**CARDINAL FREEMAN VILLAGE
137 Victoria Street, Ashfield**

**CONCEPT PLAN APPLICATION
MP 08_0245**

RESPONSE TO SUBMISSIONS REPORT

**Prepared for
Aevum Limited**

12.4m FIRETRUCK ENTERING VICTORIA ST INSET E
SCALE 1: 200

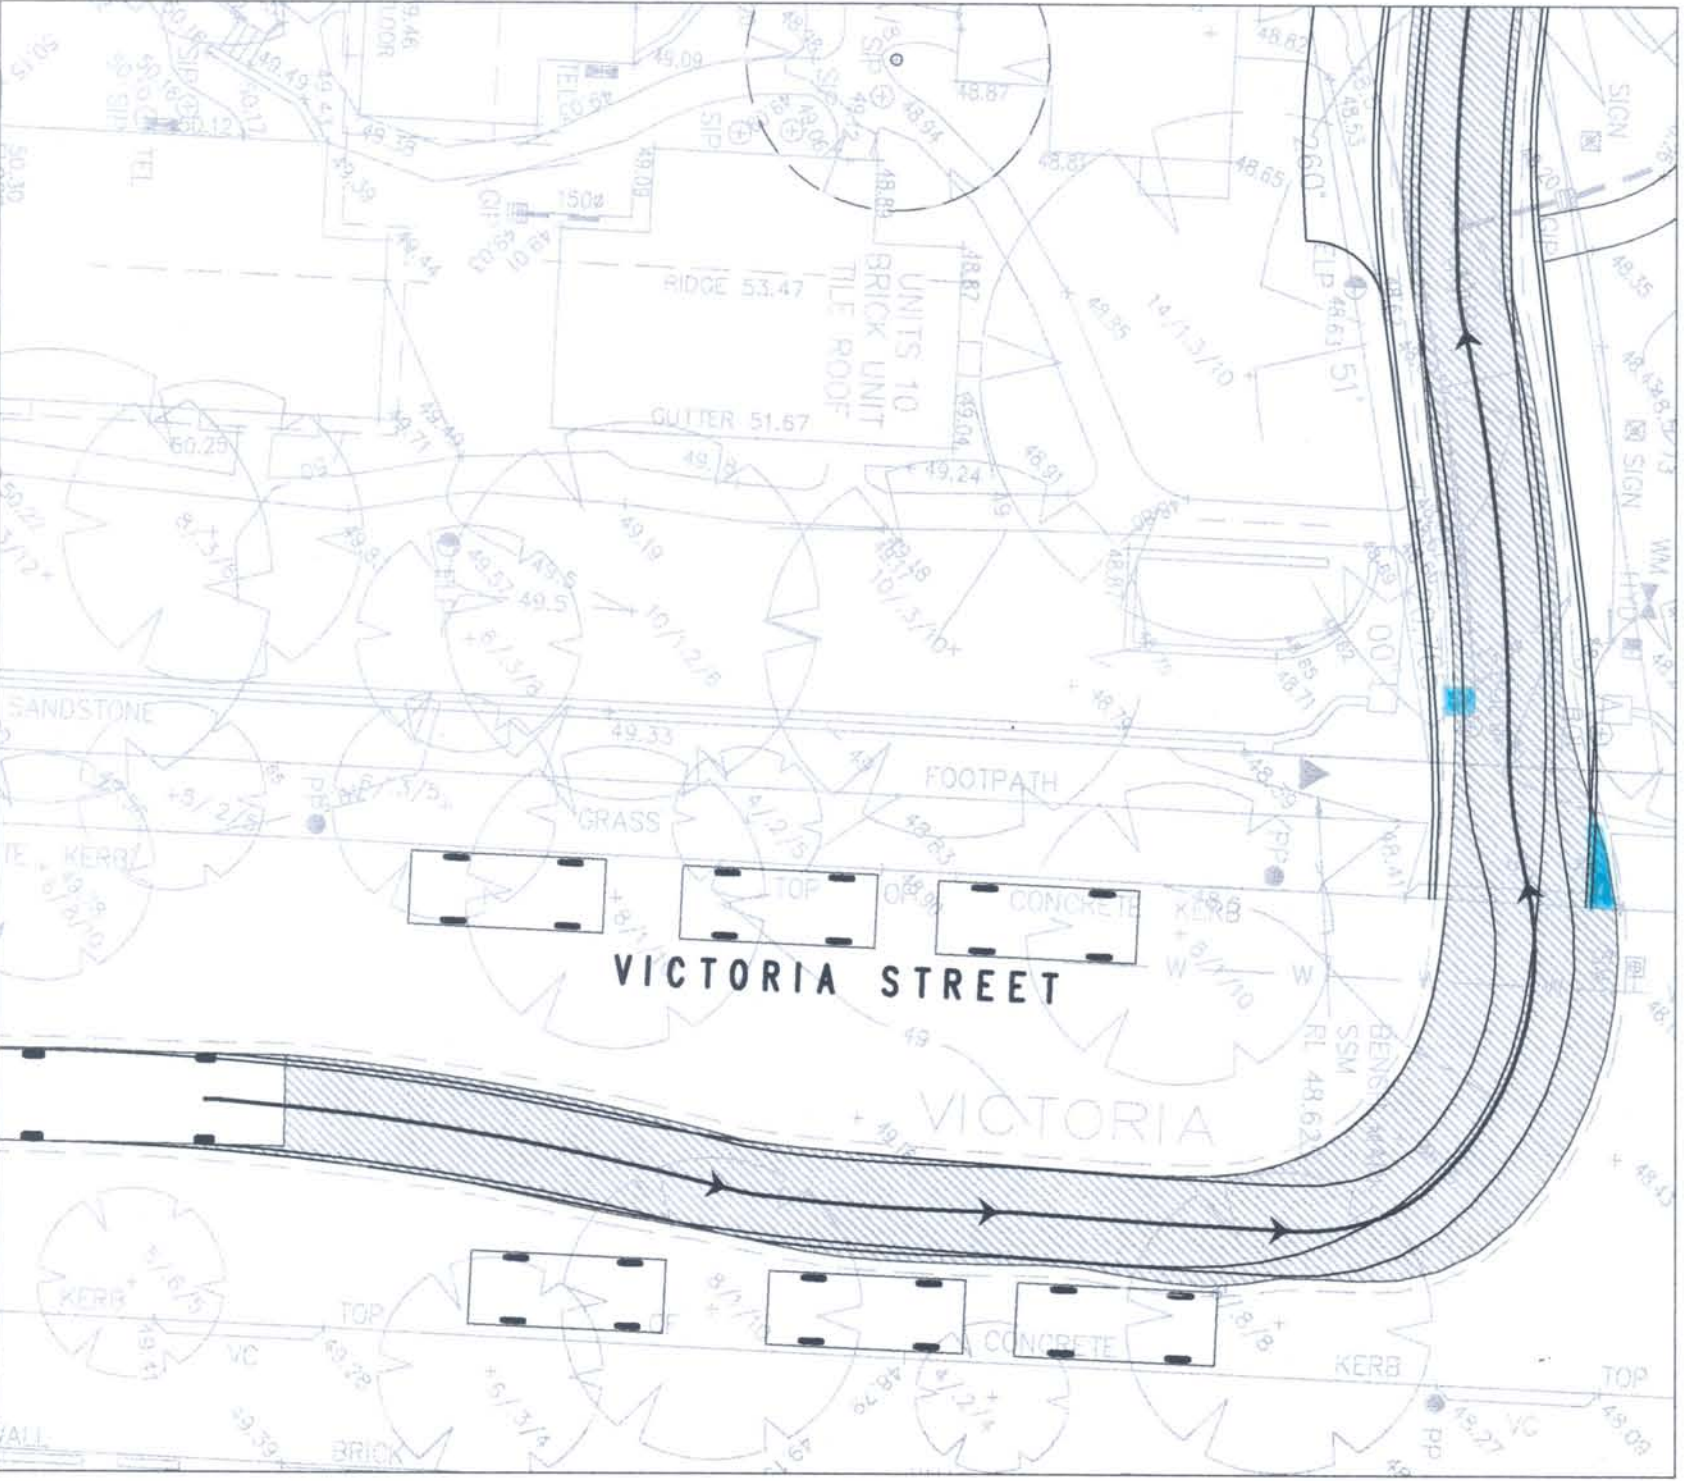
The Department has requested plans that illustrate how emergency vehicles may access the site in accordance with the NSW Fire Service Guidelines for Emergency Vehicle Access.

Waste Collection Vehicles Turning Paths

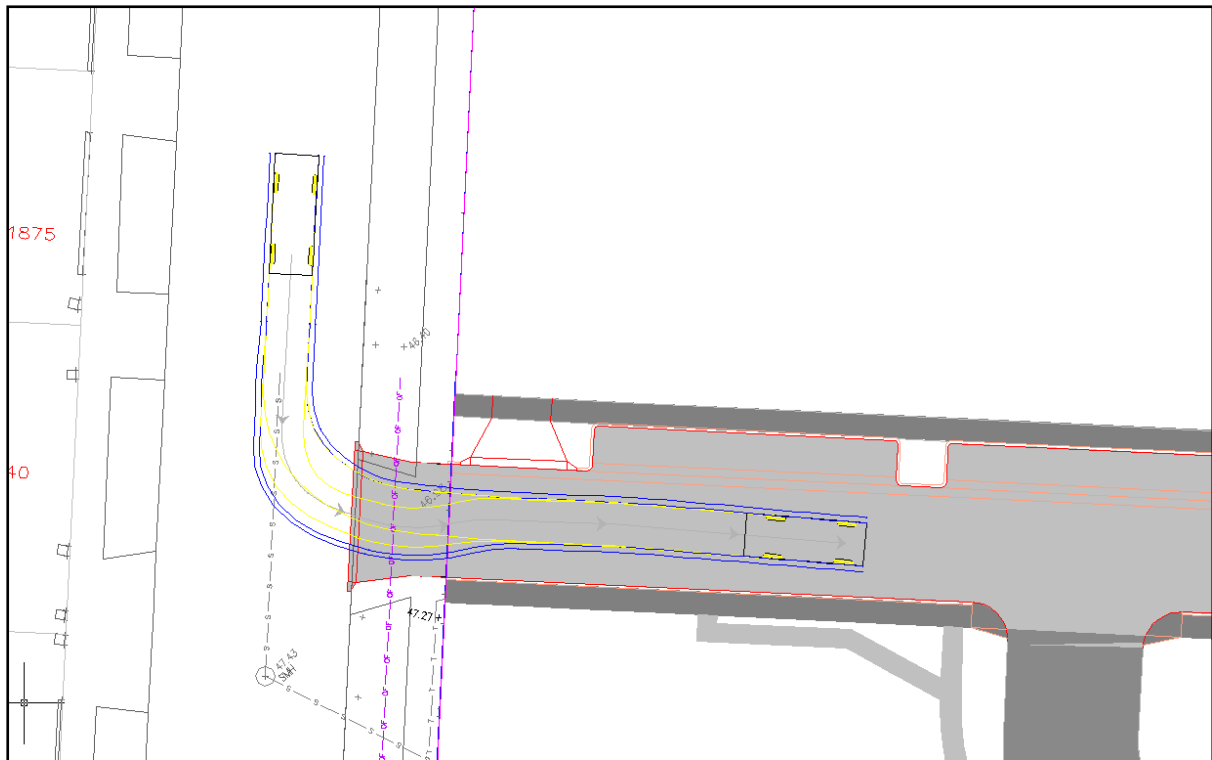
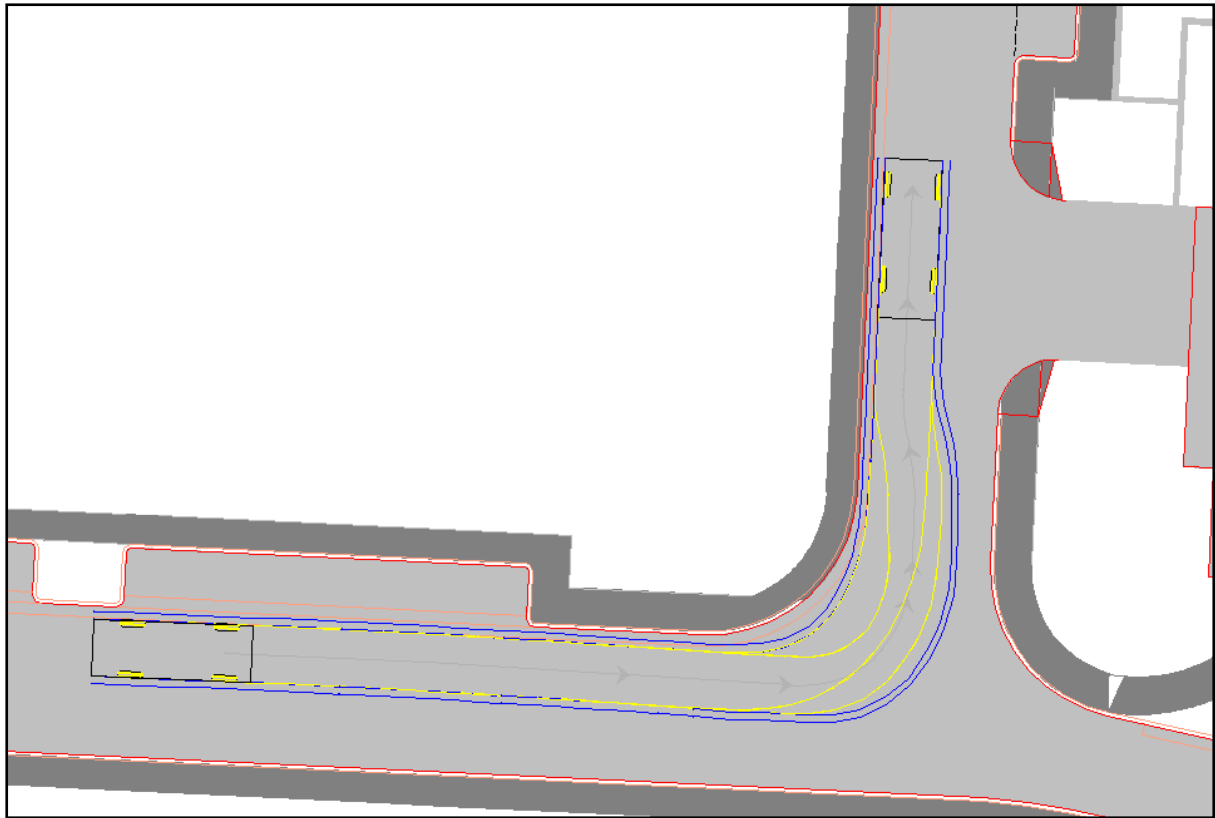
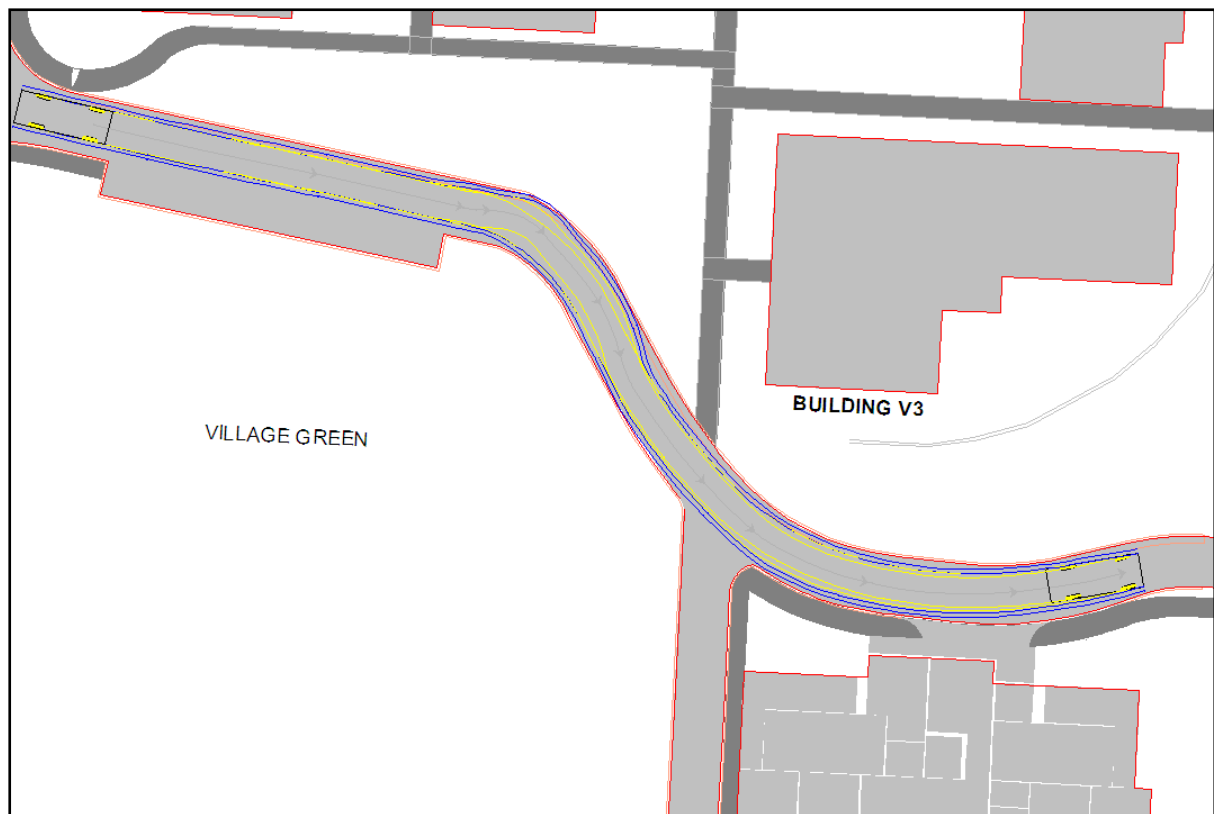
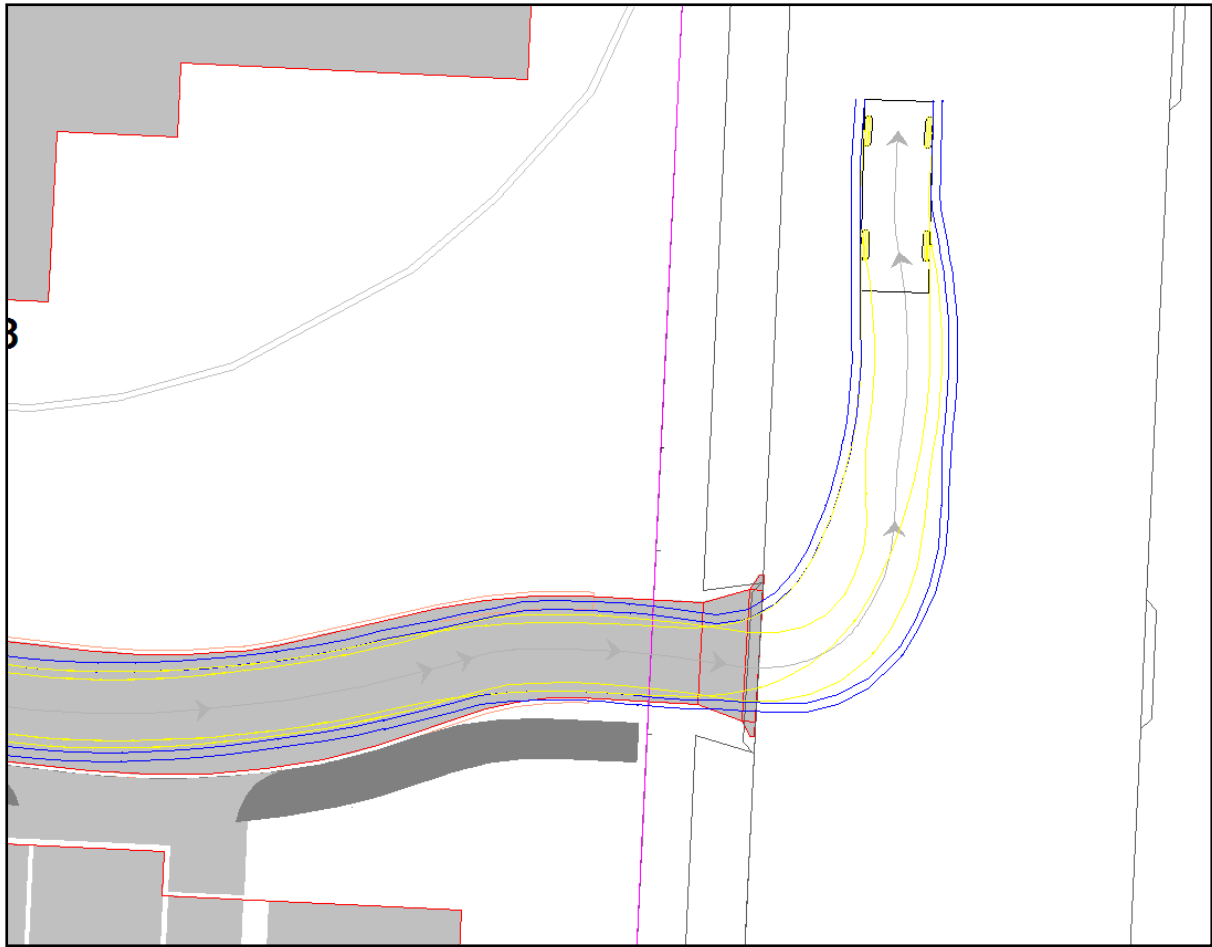
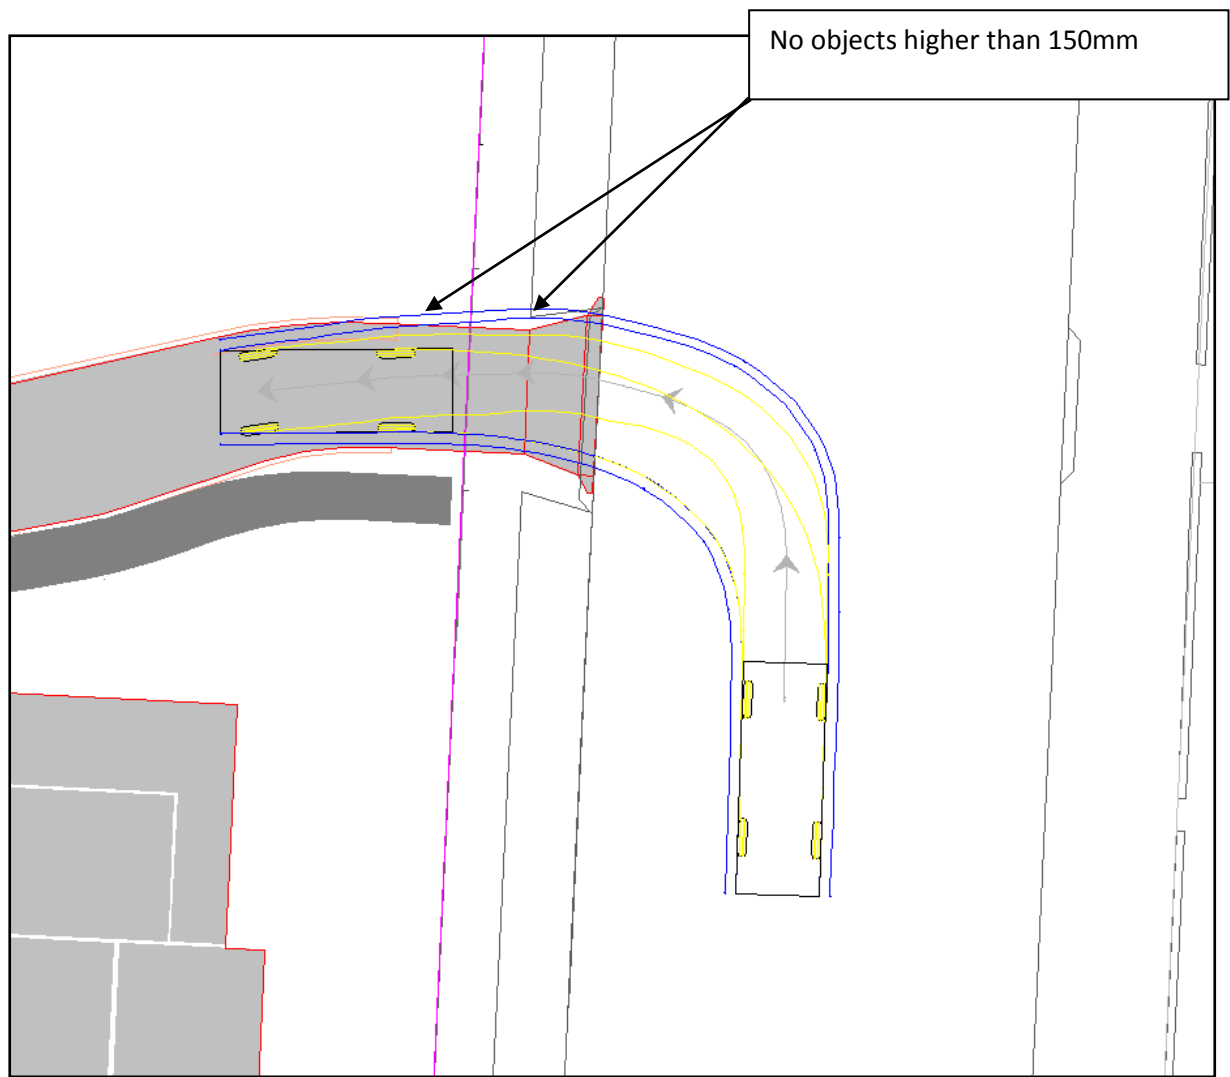
The Department has asked for plans that show how waste collection vehicles can access waste facilities efficiently without undue impact upon traffic movements throughout the site and along public streets.

The Waste Management Plan contained in Appendix K of Volume 5 of the EA outlines procedures for waste collection during operational phases. Drawings contained in the Civil Infrastructure Statement contained in Appendix M of Volume 5 show swept paths for the Small Rigid Vehicle (6.4m) which exceeds the length of the waste collection vehicle accessing the internal streets of the site. These swept paths show that the design vehicle can readily enter and leave the site via the two way section off Queen Street and the one way section off Victoria Street. Any vehicles entering and leaving via Queen Street can turn around within the site at Clissold Lane.
